Town of Hilton Head Island  
**Design Review Board Meeting**  
**Tuesday, June 22, 2021 – 1:15 p.m.**  
**AGENDA**

i. The Charles, DRB-001440-2021

i. Pope Ave Starbucks, DRB-001318-2021

## DESIGN TEAM/DRB COMMENT SHEET

1 DUMPSTER ENCLOSURE  
1/2" = 1'-0"

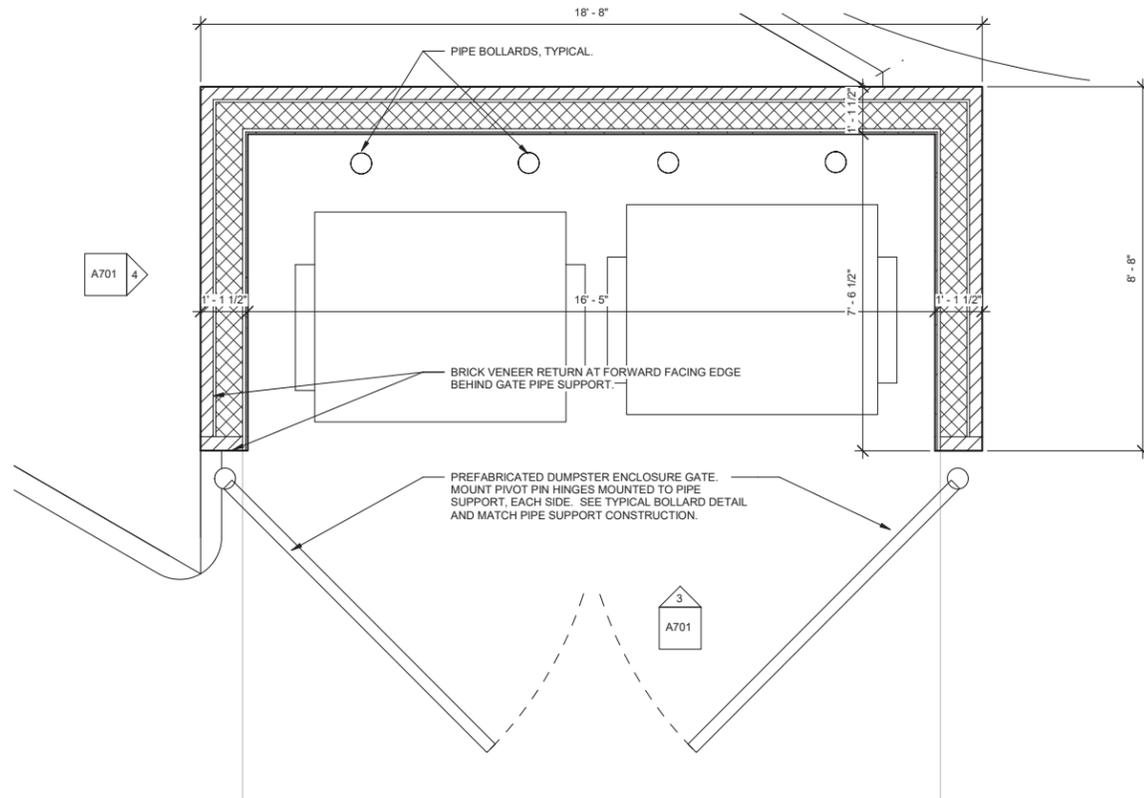
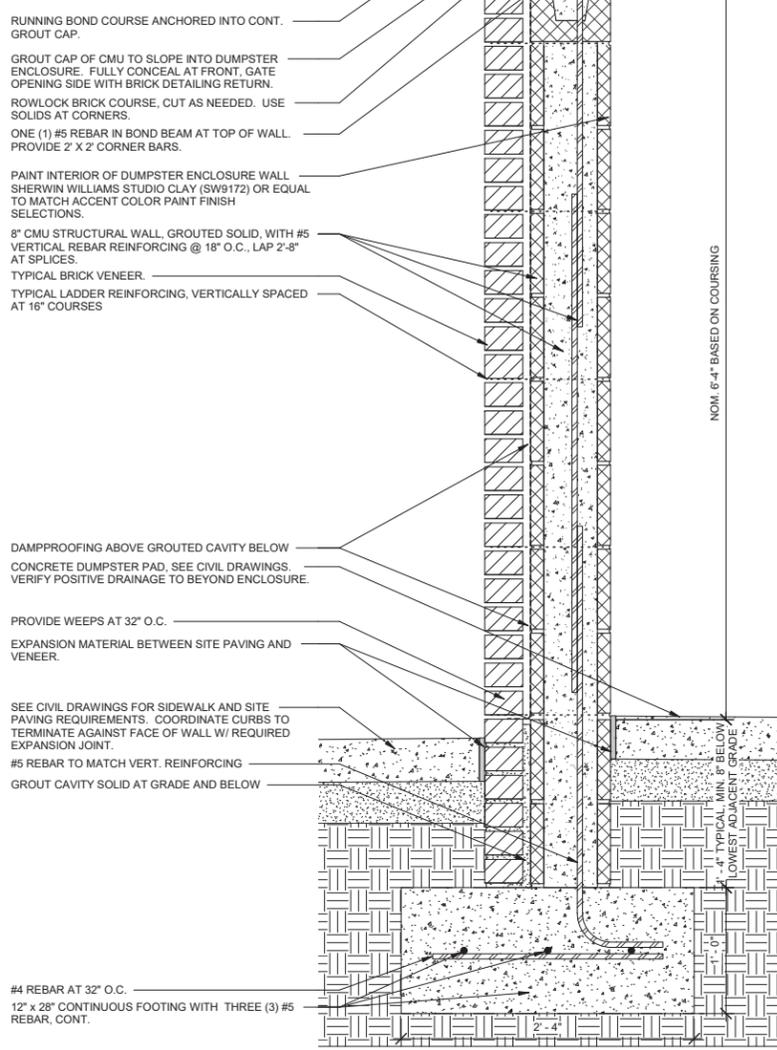
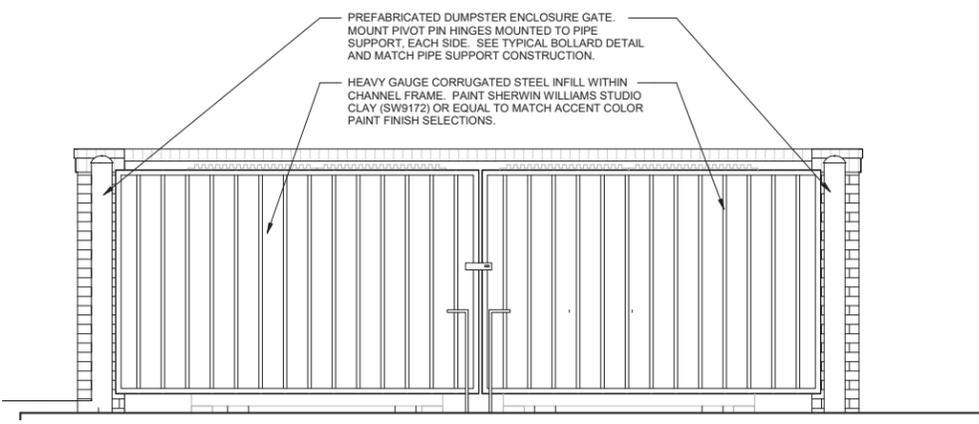
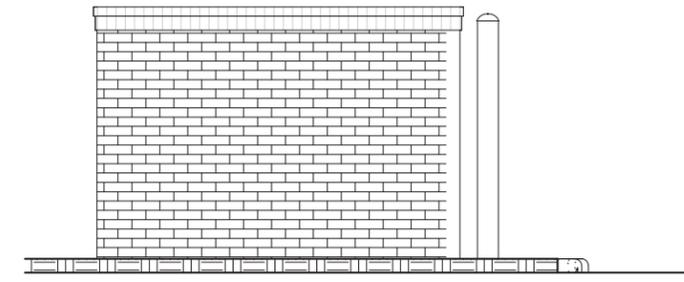
- 7) 1. Specify the color of the interior of the dumpster enclosure. – The interior of the dumpster will be painted Sherwin Williams Studio Clay (SW 9172). 2. Specify the color of the dumpster gate and gate post on the detail – The dumpster enclosure gate and posts will also be painted Sherwin Williams Studio Clay (SW 9172). These colors have been listed on the dumpster enclosure drawings/details.
